CCK-2617.0-10-24
AG RESEARCH FACILITY 1 – BP 05 TEACHING GREENHOUSE
PROJECT # 2617.0
ADDENDUM # 1
11/13/2024

UK AG Research Building
BID PACKAGE – 05 Teaching Greenhouse
ADDENDUM No. 1
CCK-2617.0-10-25
11/12/2024

Date	November 8, 2024
Project Title	University of Kentucky Agriculture Research Facility 1
To	All Plan Holders
Purpose	Modify the Bid Documents
Distribution	All Plan Holders University of Kentucky Turner Construction A/E Design Team

TEACHING GREENHOUSE - FIRST FLOOR PLAN - FIRE ALARM

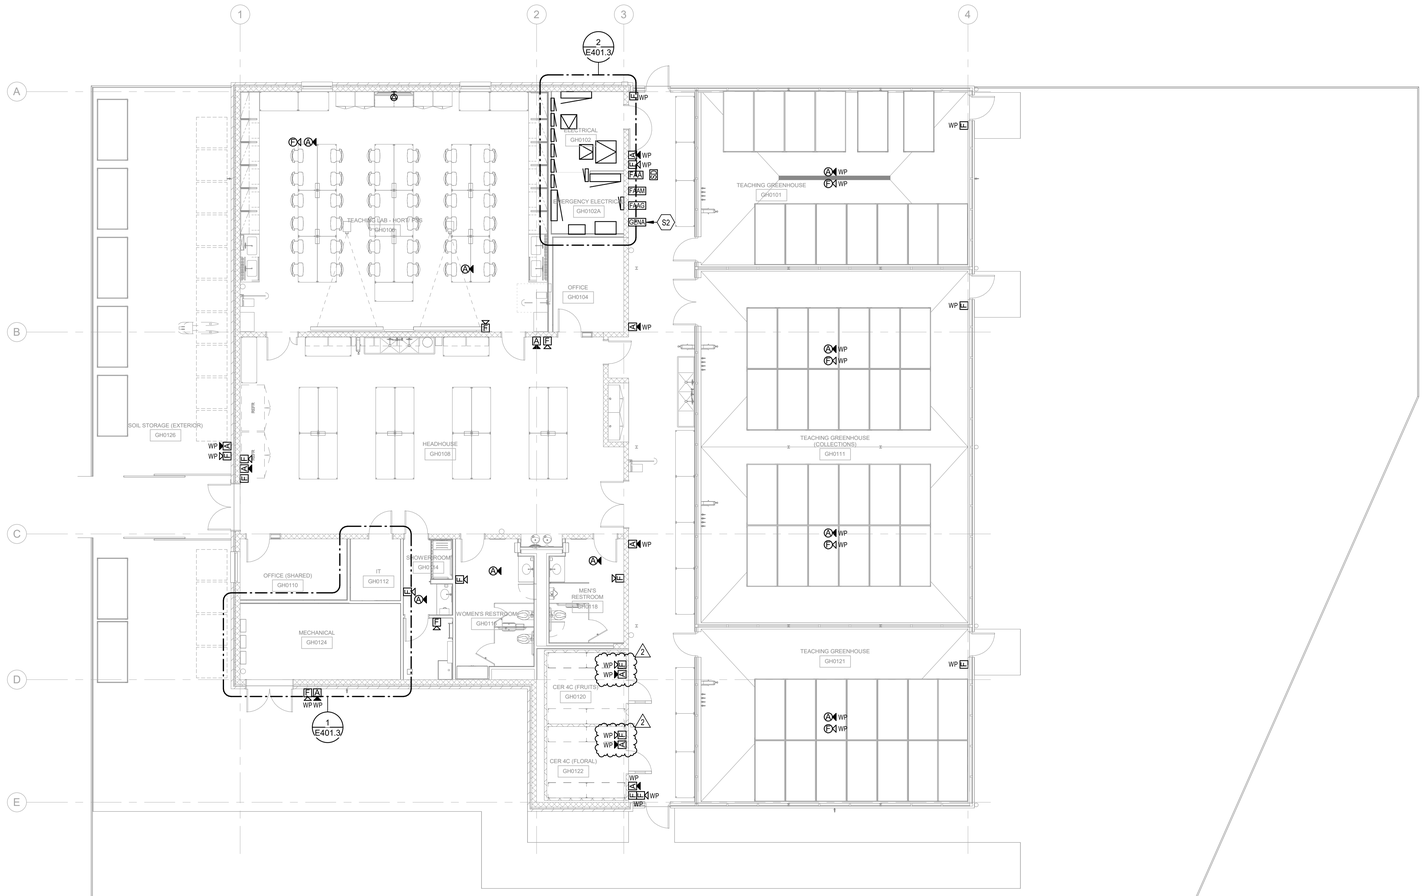
Item 18. Sheet E301.3 – TEACHING GREENHOUSE – FIRST FLOOR PLAN – FIRE ALARM
- Added fire alarm devices in CER 4C (FRUITS) GH0120 and CER 4C (FLORAL) GH0122.
